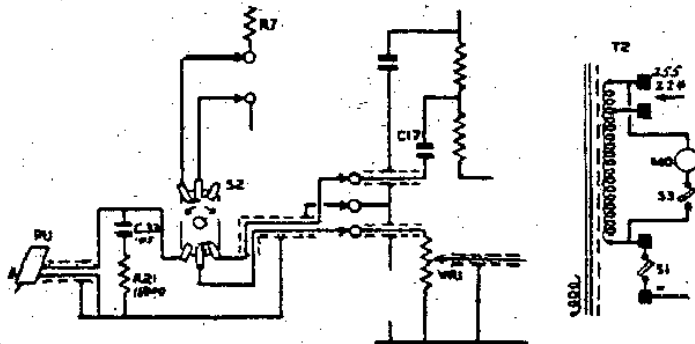
The above diagram shows the differences to the circuit for the radiograms and autoradiogram. On the latter models C14 is deleted. The resistance R21 and condenser C33 are mounted on the Radio-Gram switch S2, a practical diagram of which is shown.
